INSTRUCTION TO SERVICE

ITS: 60843		October 18, 2023
SECTION:	304- Paint & Decals	
WRITTEN BY:	Troy Stutsky	
SUBJECT:	Incorrect GVWR on Vin decal. Replace affected portion of VIN decal.	
ISSUE:	Incorrect data was provided to the production clerk responsible for VIN decal creation. The GVWR is incorrect.	
SUMMARY:	A new portion of the VIN decal will be created with the correct GVWR on it. This will be affixed on top of the incorrect information on the existing decal.

Ref. NHTSA Recall No.	Ref. Transport Canada Recall No.
23V711	Not Applicable

Figure 1: Existing VIN Decal Location

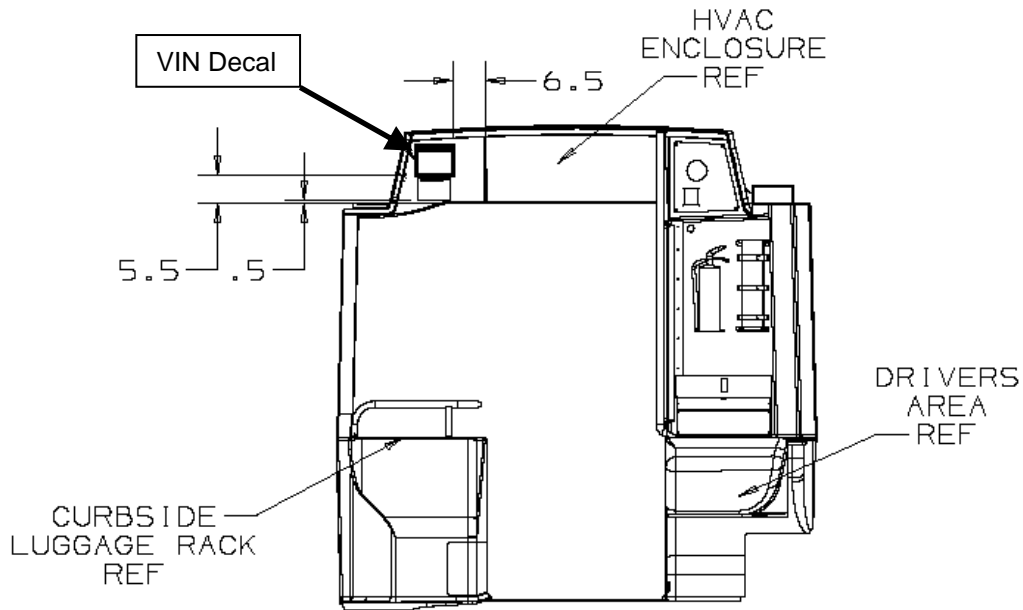
1. Set park brake and chock wheels.
2. Turn the main battery disconnect switch to the "OFF" position.
3. Locate the existing VIN decal on the HVAC enclosure. See Figure 1.

4. Carefully center and affix the new decal portion (NF PN 055088) with the correct GVWR information on it directly over the existing decal with the incorrect GVWR information or it. See Figure 2.
